TITLE	CAM1800
AUDIO WCU HD

THOMSON BROADCAST SYSTEMS	DRAWING No	REV	CODE	SIZE	SHEET
	3922 406 52161	B	030	3	0

EVOLUTION SCHEMA
SCHEMATIC CHANGE

ON SOLDER SIDE

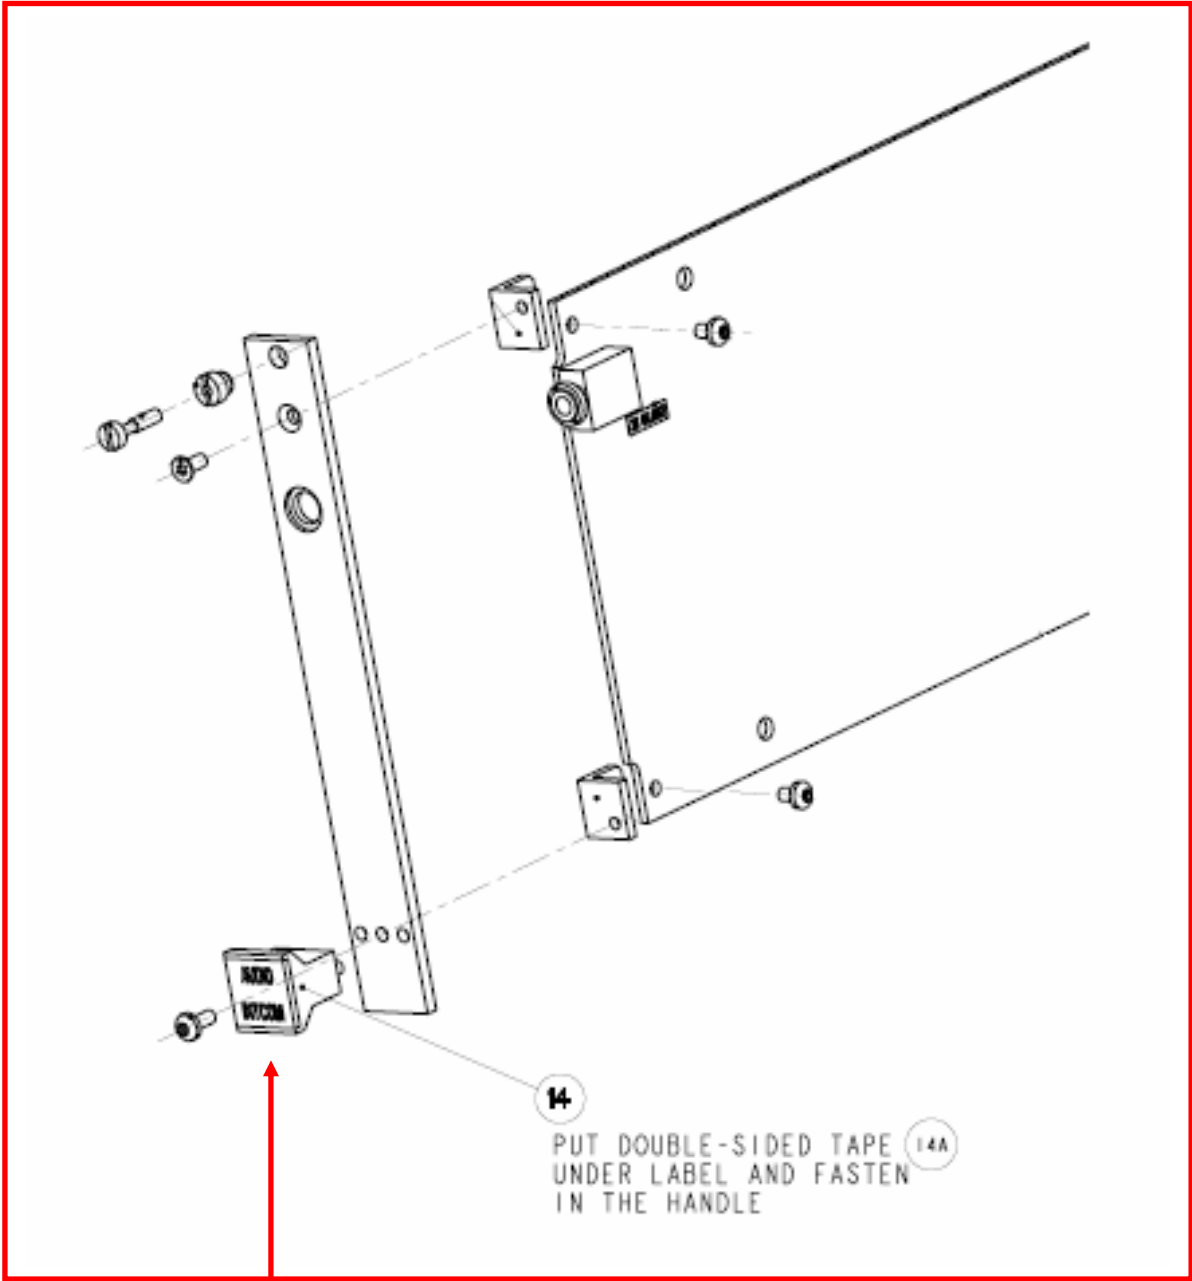
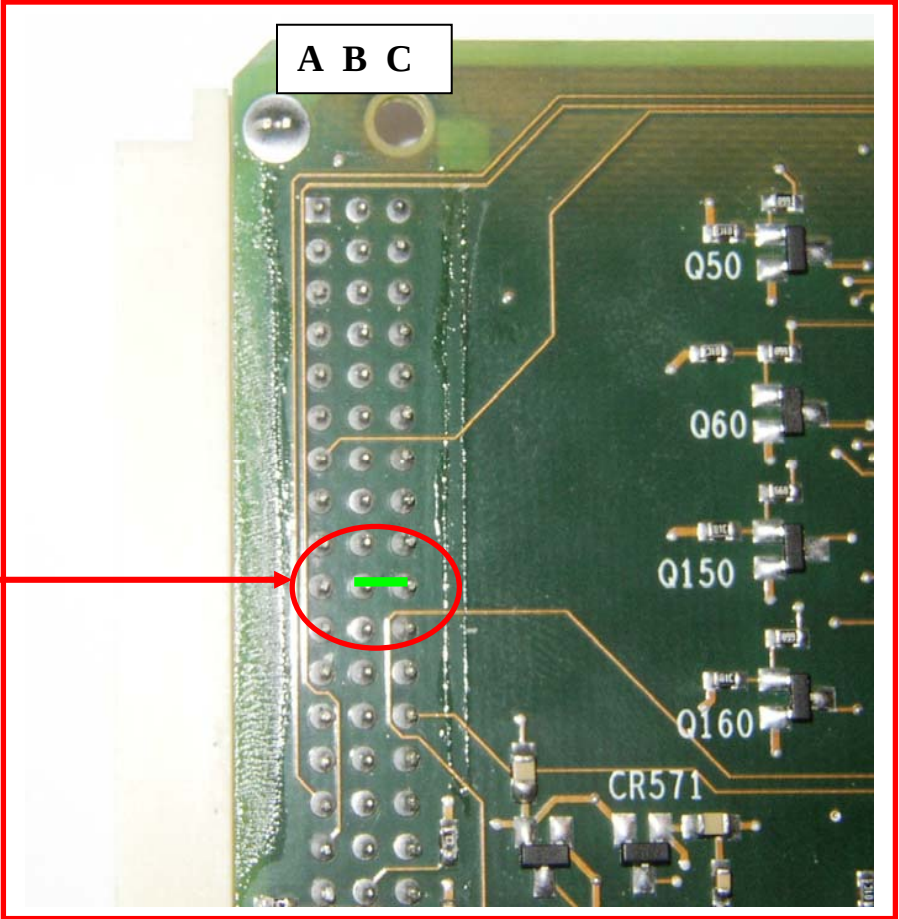
CHD00891 _ Connect Pin B10-P1 to C10-P1.

CHD00844 _ Replace old label ref 14 with new one (HD) on front plate of the board.

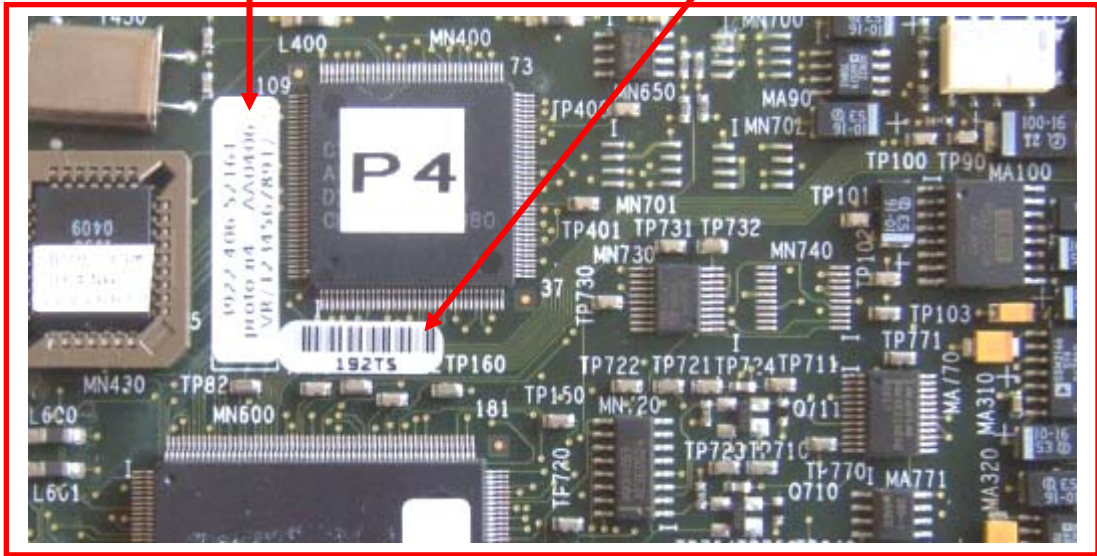
CHD00854 _ Remove old identification label (16832184AB) and old Prod ID label
Stick here the new **Identification (Rep50)** and the new **Prod ID label (Rep55).**
